#3037730-LU
4734 31st Ave S
Recommendation Phase
August 2022

4734 31st Ave S
SDCI# 3037731-EG

Demolish existing SFR. Construct new apartment building with 42 Small Efficiency Dwelling Units (SEDUs). No parking provided.

View from Southwest Corner

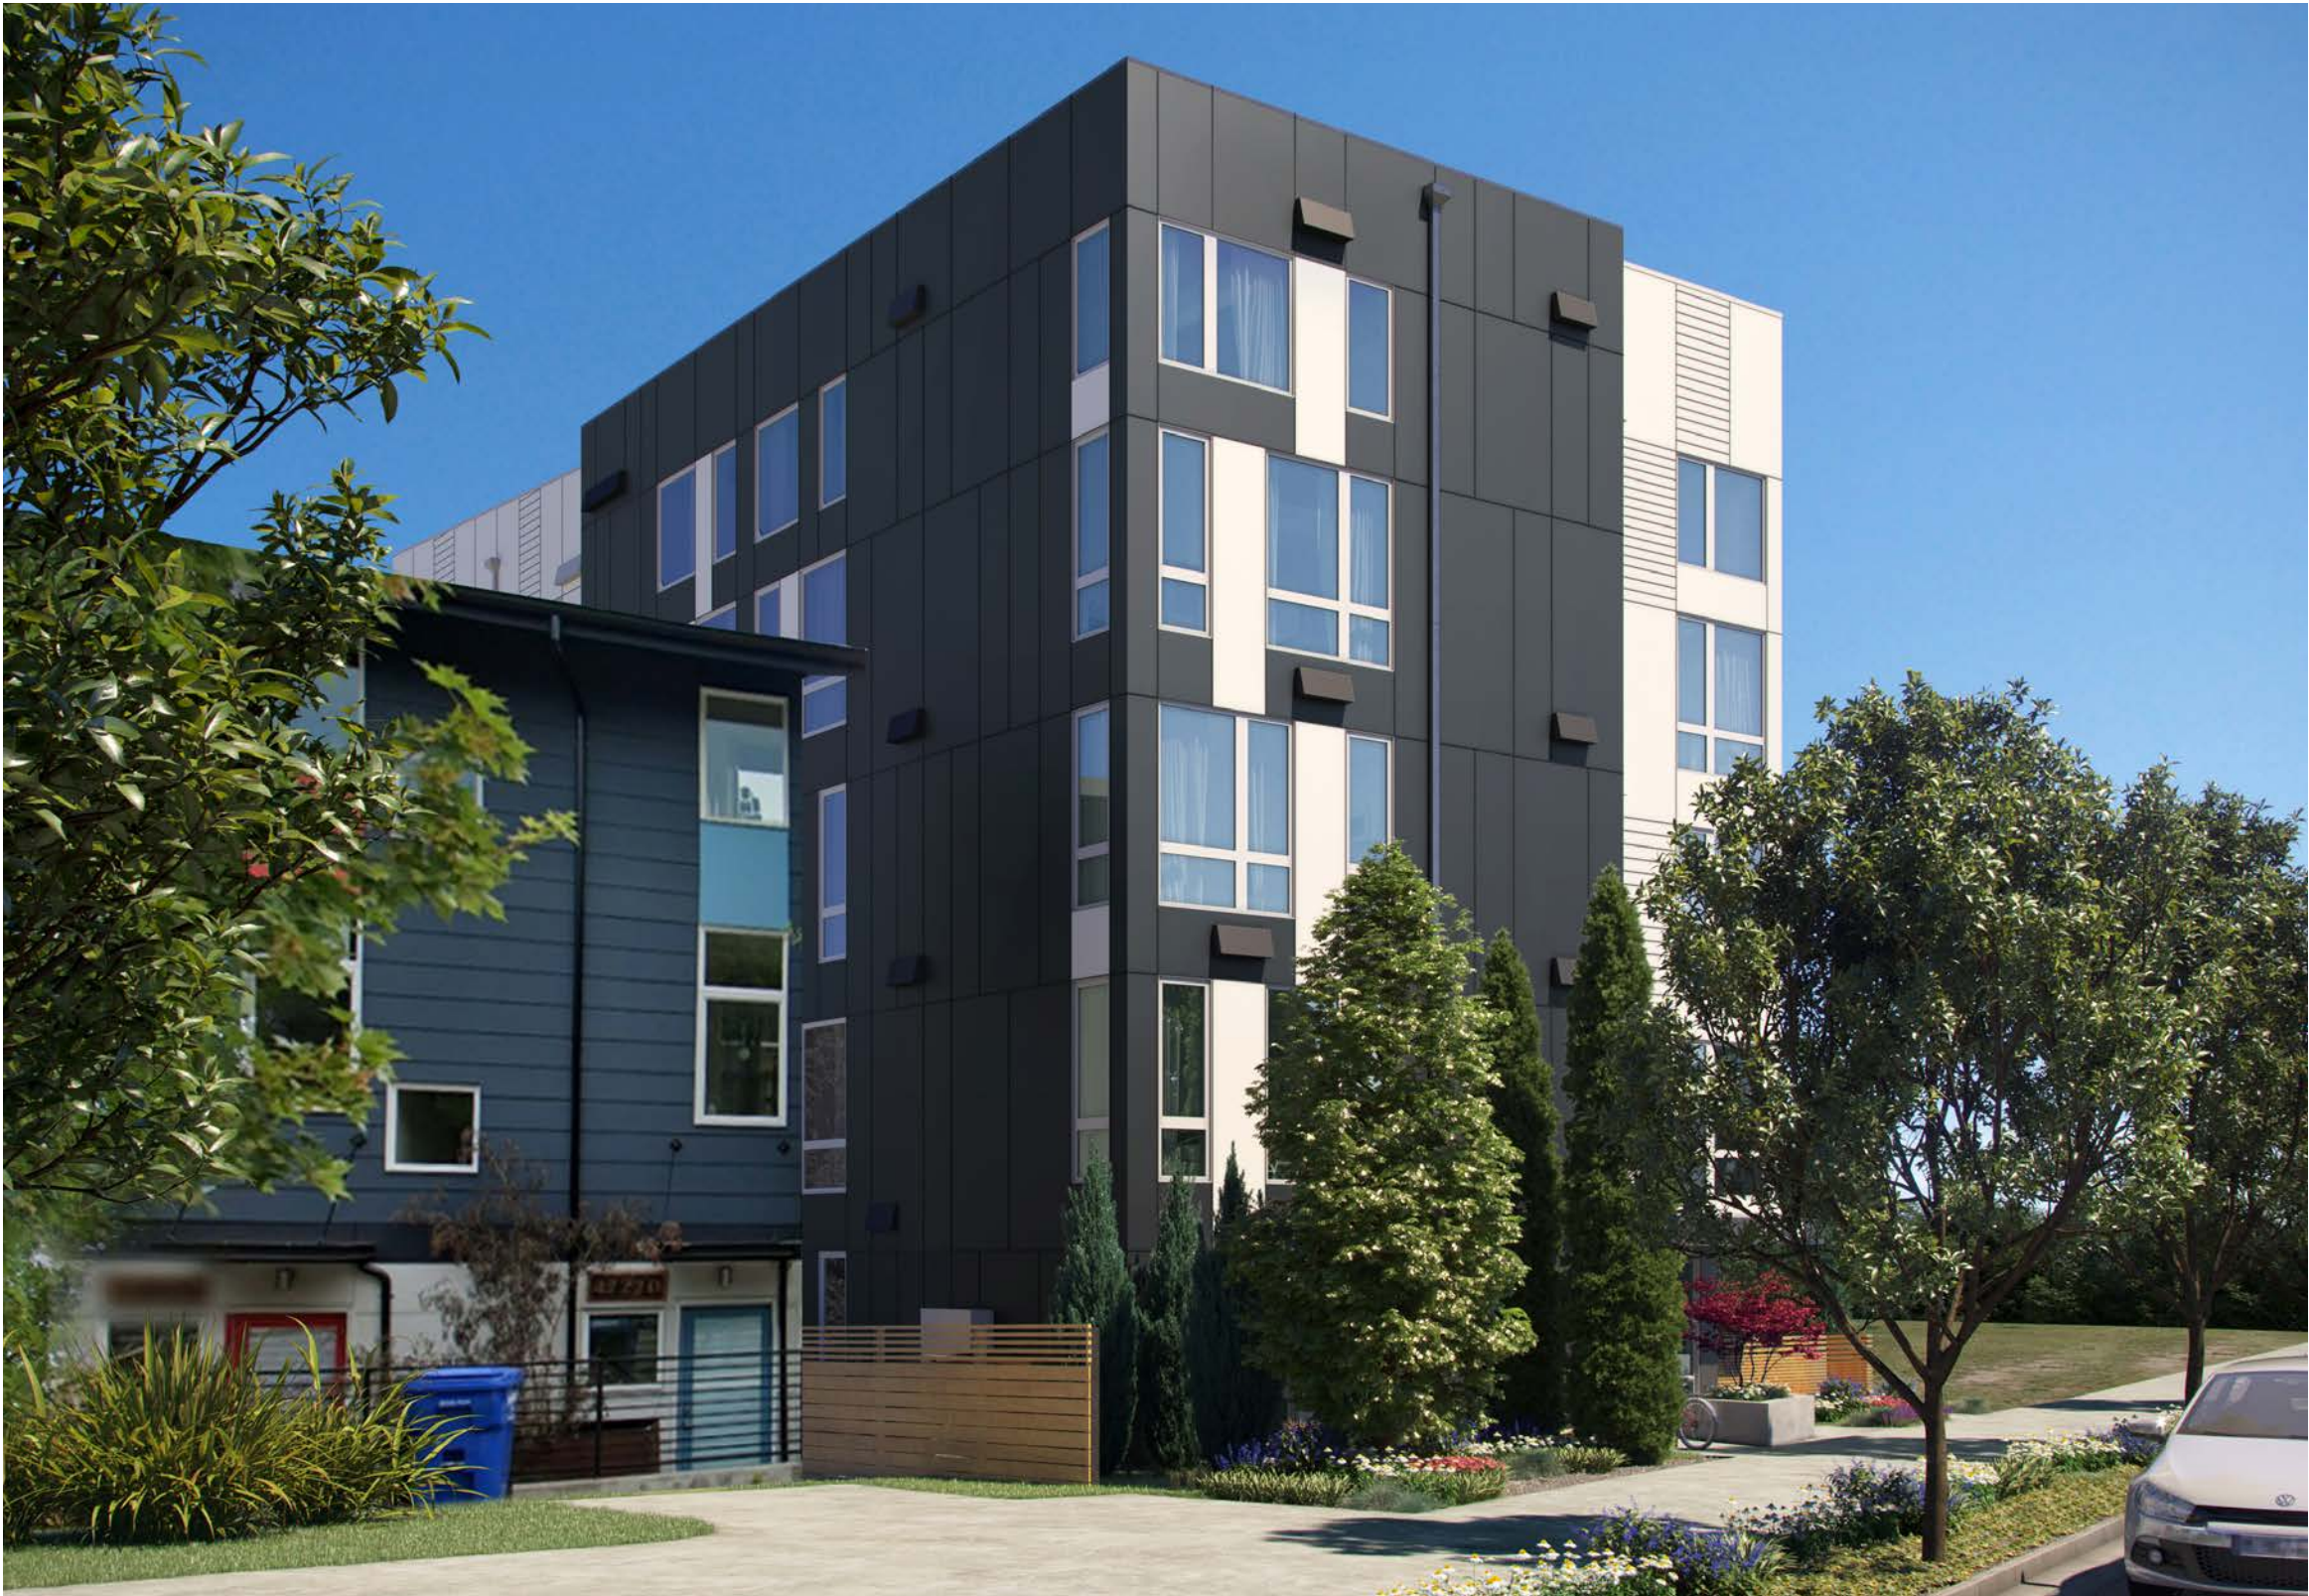
a. Staff supports the massing of Scheme C within the EDG packet over the other options due to residential entry prominence, the conceptual façade expression of the south façade, and the organization of ground-level outdoor open space (DC2-B-1. Façade Composition, DC1-A-4. Views and Connections, DC3-B. Open Space Uses and Activities).

b. Staff supports the clear massing expression of Scheme C along the south property line with east and west massing elements separated by a circulation core and a conceptual intent for a complementary window pattern aiding in this expression. Due to the presence of an undeveloped parcel to the south, this south façade may be highly visible (DC2-A-2. Reducing Perceived Mass, DC2-B. Architectural and Façade Composition).

c. The overall complementary massing and window patterns appear to be less cohesive on the west façade, where massing and window patterns are designed to relate to the adjacent façades and lack a coherent design facing the street. Of the three schemes, Scheme B presents the most cohesive massing and conceptual window pattern design to the street frontage. Please analyze massing refinement, orientation of interior units, composition of window patterns, and the application of exterior materials to ensure a well-designed street-facing façade composition. Include a summary of this analysis at the Recommendation phase of review (DC2-B. Architectural and Façade Composition, DC2-C. Secondary Architectural Features).

a. Staff prefers the entry design of Scheme C over the other options due to its emphasis of the residential entry and lobby along the west and south façades using fenestration and a ground-level setback. Along with guidance above in 1c, staff recommends refinement of the massing and window pattern of the west façade design to emphasize residential entry (PL3-B-2. Ground-Level Residential, DC2-A-1. Reducing Perceived Mass, DC2-B-1. Façade Composition).

Design Response: 1a 1b 1c 5a 5b

Ground-level massing pulls in at the entry corner to provide an entry plaza. Building massings are wrapped in a contrasting palette of white and black materials. A mix of rigor and irregularity creates a language of rhythm, texture, and interest. The white volumes establish order with stacked windows and vertically oriented panels. Panel size fields of lap siding are integrated to create a subtle and playful texture. The volumes formed by interior circulation are expressed with black corrugated metal siding and white infill panels.

The black volumes establish order with vertical groups of windows. However, that rigor is broken up with staggered windows and panel pattern. White infill panels emphasize the irregularity of the offset windows.

SITE PLAN

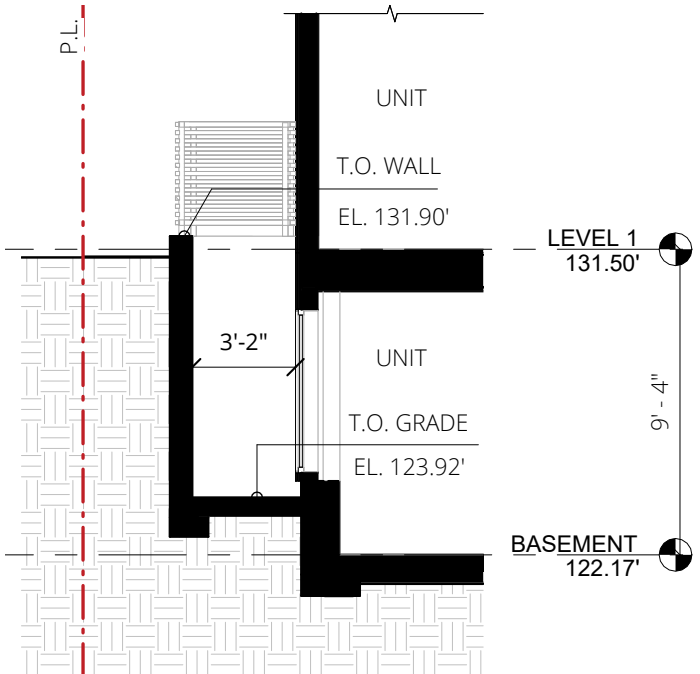
b. Examine design refinements to strengthen the entry sequence, incorporating lighting, signage, additional overhead weather protection and other design elements to create a distinctive and welcoming entry. (PL2-D-1. Design as Wayfinding, PL3-A-2 Ensemble of Elements, PL3-B-2. Ground-Level Residential).

Staff supports the conceptual patio space layout of Scheme C, which uses two distinct patio spaces near the southwest corner of the site. The western patio space serves as a point of interaction between the residential entry and the public sidewalk. The eastern patio space appears to be a quieter, yet visible, space from the sidewalk. Both spaces are likely to have access to sunlight due to their locations near the southwest corner of the site. Maintain these aspects of the proposed open space which serve distinct functions for building residents (PL2-B-1. Eyes on the Street, CS1-B-2. Daylight and Shading, DC3-B-1. Meeting User Needs).

a. Along with guidance above to strengthen the appearance of the residential entry, utilize landscaping along the street frontage to emphasize the residential entry location (PL3-B. Residential Edges, DC3-C-2 Amenities and Features, DC4-D. Trees, Landscape, and Hardscape Materials).

b. Requested façade length departures associated with Scheme C are intended to allow for increased residential street setbacks. At the Recommendation phase, demonstrate how landscaping will be designed to complement the deeper setback to ensure privacy for ground-level residential units and to provide a visually appealing street frontage (DC3-C-2 Amenities and Features, DC4-D. Trees, Landscape, and Hardscape Materials).

Design Response: (2b) (3) (4a) (4b)

The primary residential entry remains on the highly visible SW corner, with the entry plaza establishing a direct connection between entry and sidewalk. The south patio is buffered from the entry plaza and sidewalk, and provides a variety of gathering spaces for residents. A small patio in the east yard has seating and planting for residents. A deep planting triangle in the NW corner of the site emphasizes the increased front setback.

Building Section A - Scale: 1/16" = 1'-0"

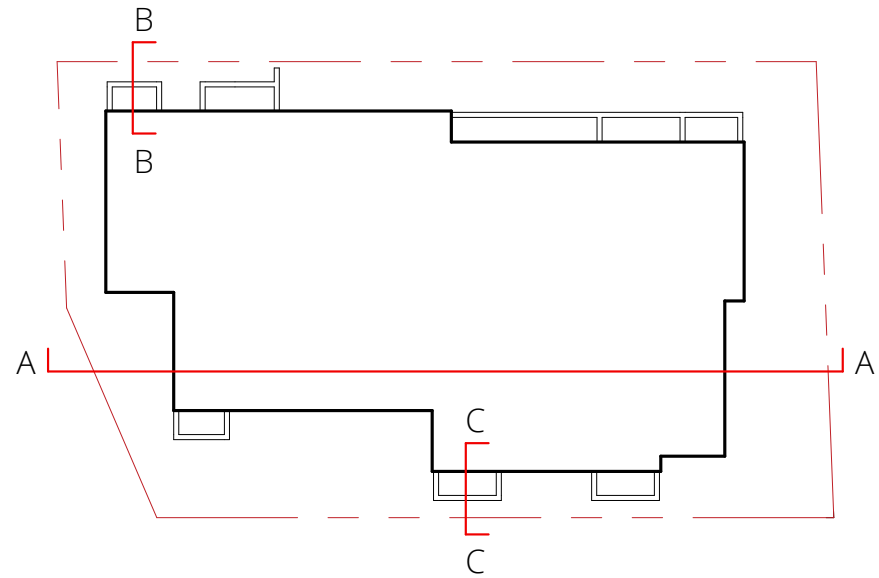
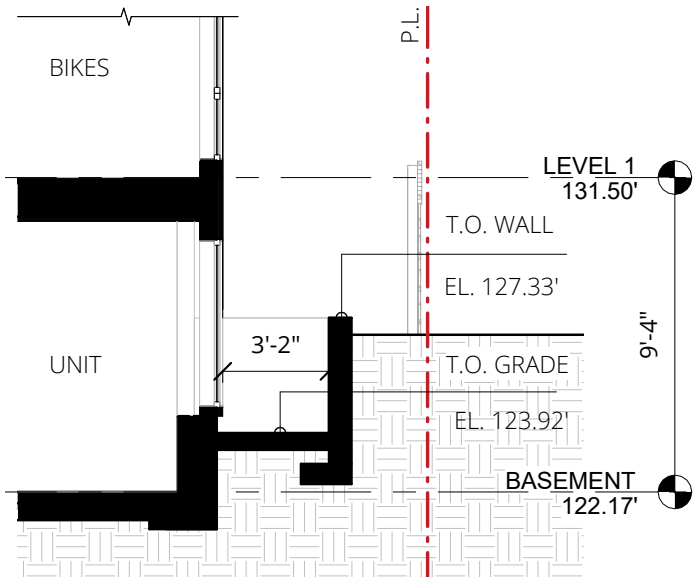
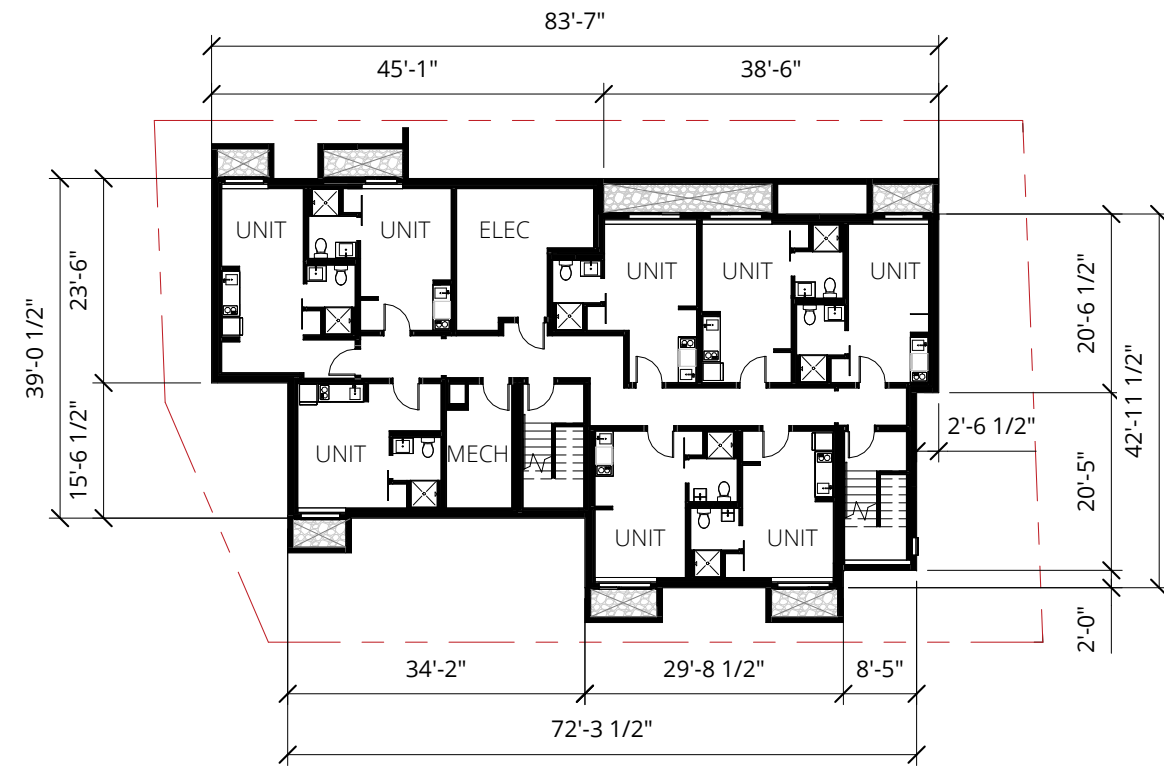
d. Ensure that basement-level residential units have sufficient access to light through the design of light wells. At the Recommendation phase of review, provide detailed information showing the relationship of grade to the basement and ground-level uses, including dimensioned section drawings (CS1-C. Topography).

Project Response:
Exterior material palette and window composition establish a rigor that can be interrupted by a playful irregularity of pattern and texture. Site lighting enhances wayfinding and safety. Window wells have been further developed.
See pages 12, 13, 20-23 for demonstration.

Key Plan - Amenity Spaces

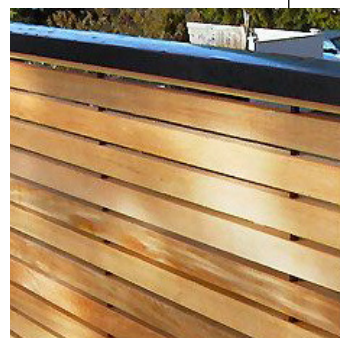
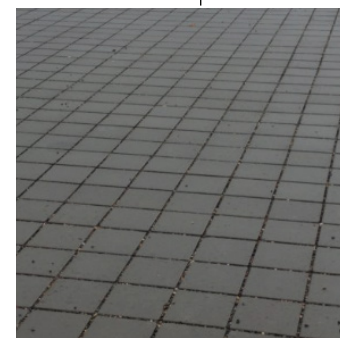
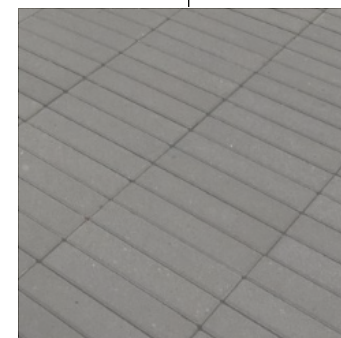
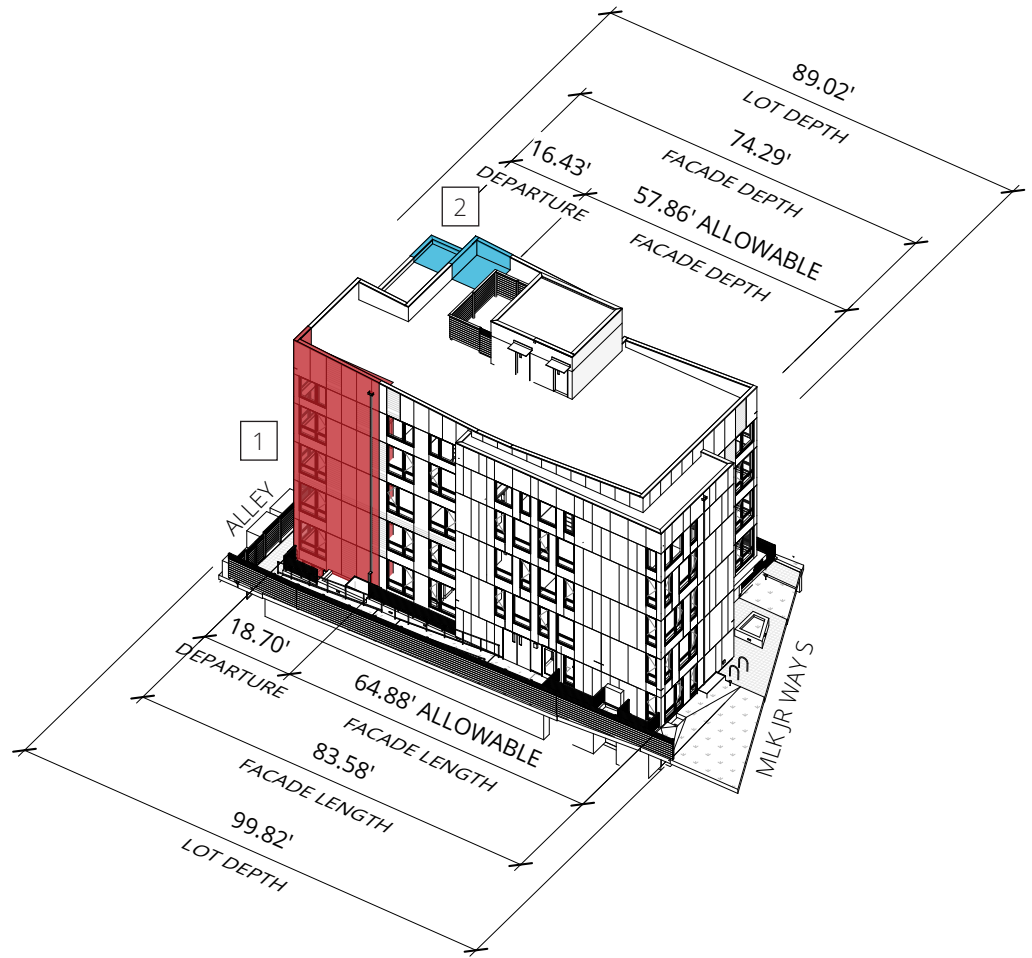
The wooden guardrail surrounding the secondary patio space diminishes the strength of the relationship between the patio spaces and reduces the visibility from and connection to the right-of-way. Revise the design to fully utilize the space to create a strong urban edge.

Regarding new departure request (reduction of amenity space): Ground-level amenity requirements are satisfied. Identify constraints to providing rooftop amenity area.

Project Response:
The entry plaza and south patio have been maintained and further developed as two distinct spaces, with the addition of a third amenity space in the east yard.
See 14, 24, 25, 26, 27, 28 for demonstration.

*Note: This is a non-elevator building so rooftop is not accessible. Amenity area cannot be provided at roof.

Design Response: ③
The south patio extends from the lobby to create a space for residents to gather with a variety of seating and planting. The east patio is further removed from the ROW and entry, providing a quiet space for residents with benches and landscaping.

Wood Guardrail, 2x2 Cedar on Metal Frame Prefinished Black
3 ft tall fence maintains visual connection with entry plaza & buffers patio from ROW.

Wood Fence, 2x6 Cedar on 4x4 Wood Posts
3 ft tall fence maintains visual connection with entry plaza & buffers patio from ROW.
